**Economic Commission for Europe****Inland Transport Committee****World Forum for Harmonization of Vehicle Regulations****Working Party on Lighting and Light-Signalling****Seventy-ninth session**

**Simplification of lighting and light-signalling Regulations****Proposal for Supplement [11] to the 06 series of amendments to Regulation No. 48 (Installation of lighting and light-signalling devices)****Submitted by the Informal Working Group on Simplification of Lighting and Light-Signalling Regulations (IWG SLR)\***

Example of a light guide optic or a reflector optic behind an outer lens:

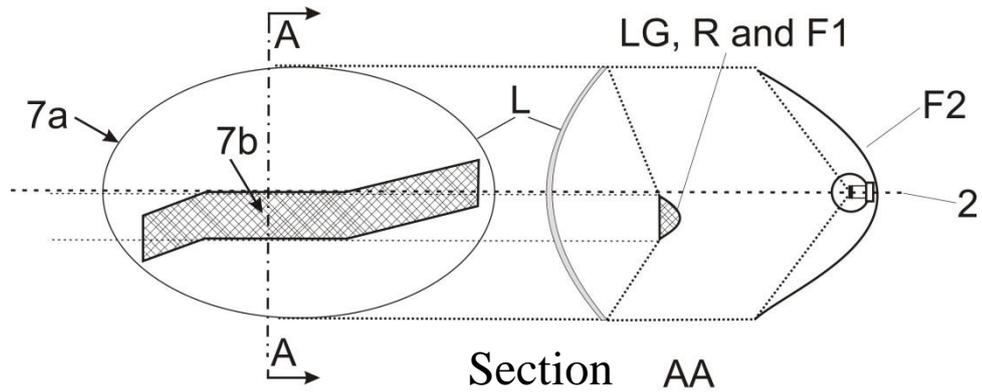
In the case where the non-textured outer lens is excluded, "7b" is the apparent surface according to paragraph ~~2.8.~~**2.10.2.** (b).

Example 8

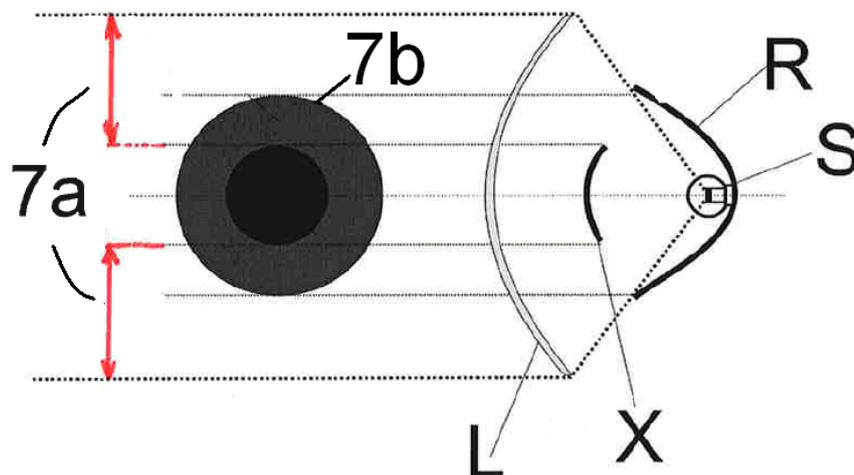
In the case where the non textured outer lens is excluded, "7b" is the apparent surface according to paragraph 2.8. 2.10.2. (b), and F1 shall not transparent to F2

Example 9

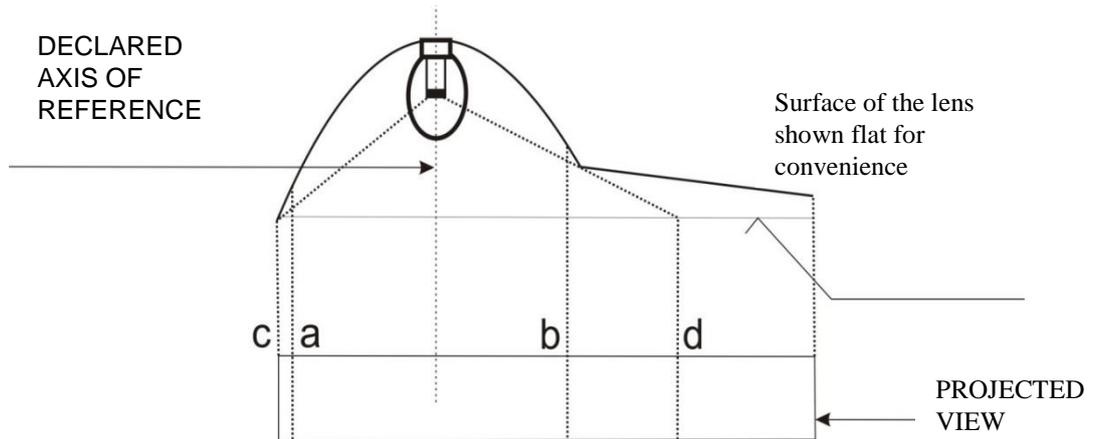
In the case where the non textured outer lens is excluded, "7b" is the apparent surface according to paragraph 2.8. 2.10.2. (b).

Example A

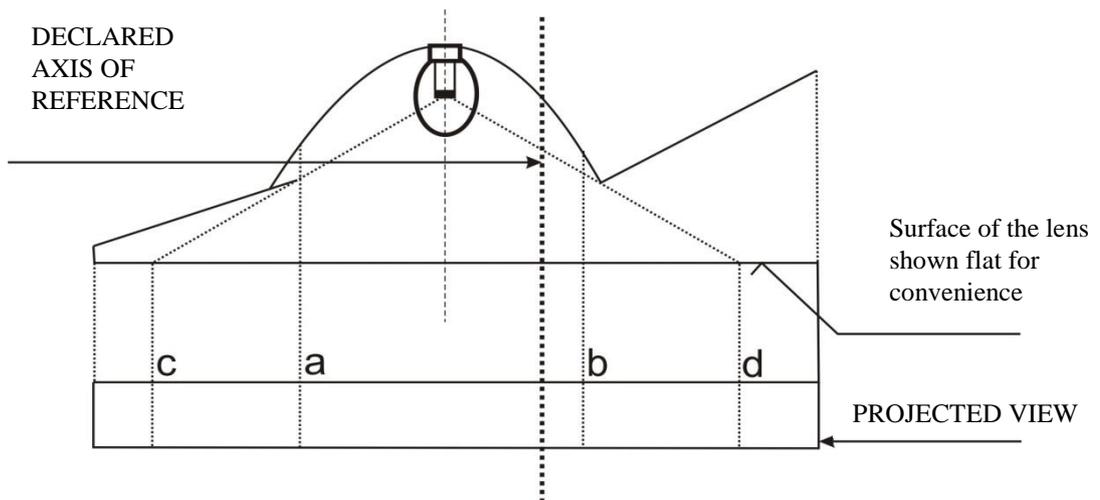
<i>Illuminating surface</i>	<i>Declared light-emitting surface according to 2.8. 2.10.2. (a)</i>
Edges are	a and b	c and d

Example D

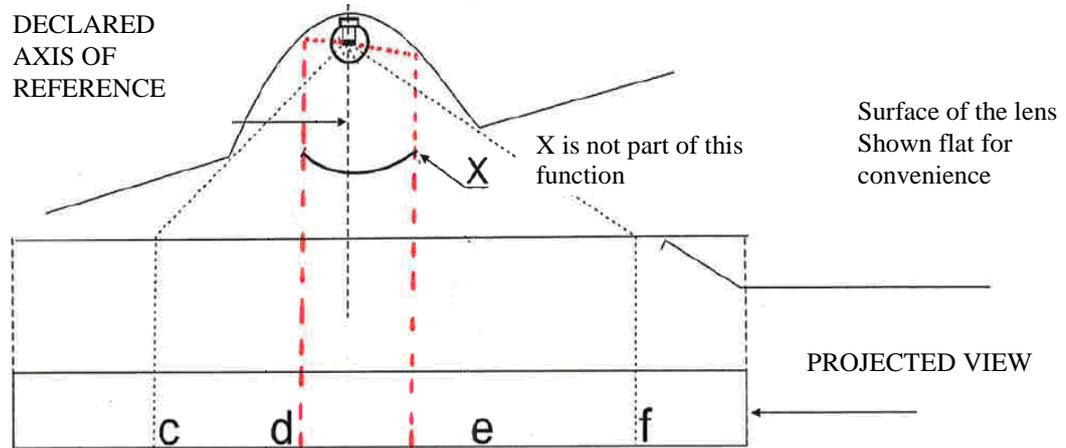
Example to determine a light emitting surface according to 2.8-2.10.2. (a) in combination with an area which is not part of the function:

<i>Declared Light-emitting surface according to 2.8-2.10.2. (a)</i>
Edges are	c-d and e-f

Example E

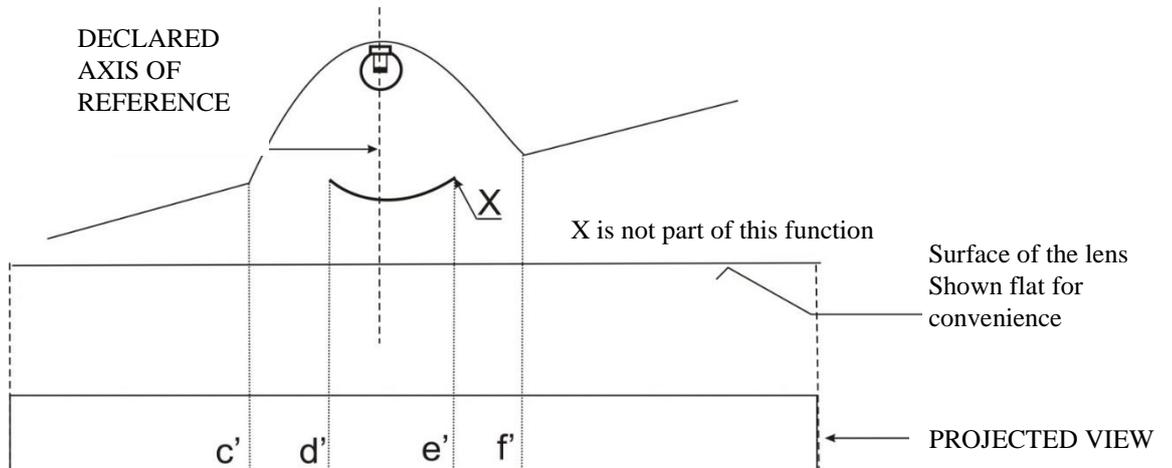
Example to determine the apparent surface in combination with an area which is not part of the function and a non-textured outer lens (according to 2.8-2.10.2. (b)):

<i>Declared Light emitting surface according to 2.8-2.10.2. (b) for example</i>
Edges are	c'-d' and e'-f'

Part 7, amend to read:

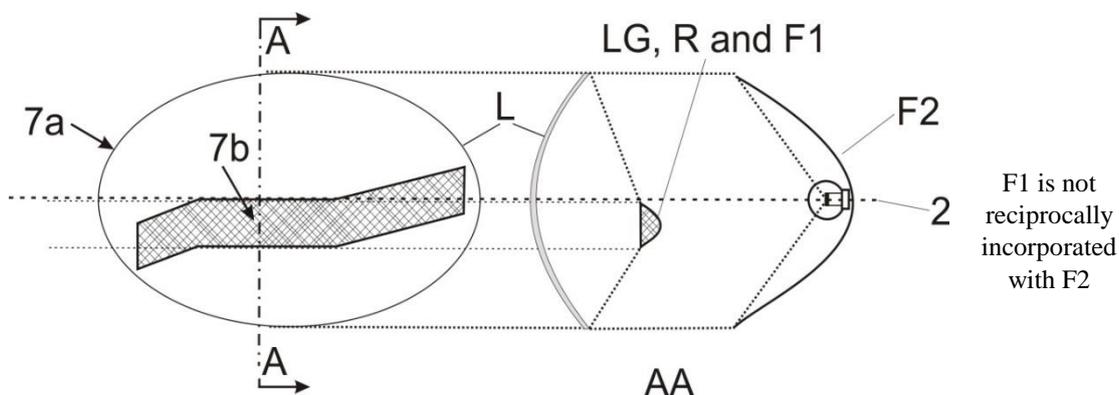
In the case where the non-textured outer lens is excluded, "7b" is the apparent surface according to paragraph ~~2.8.~~**2.10.2.** and F1 shall not be transparent to F2:
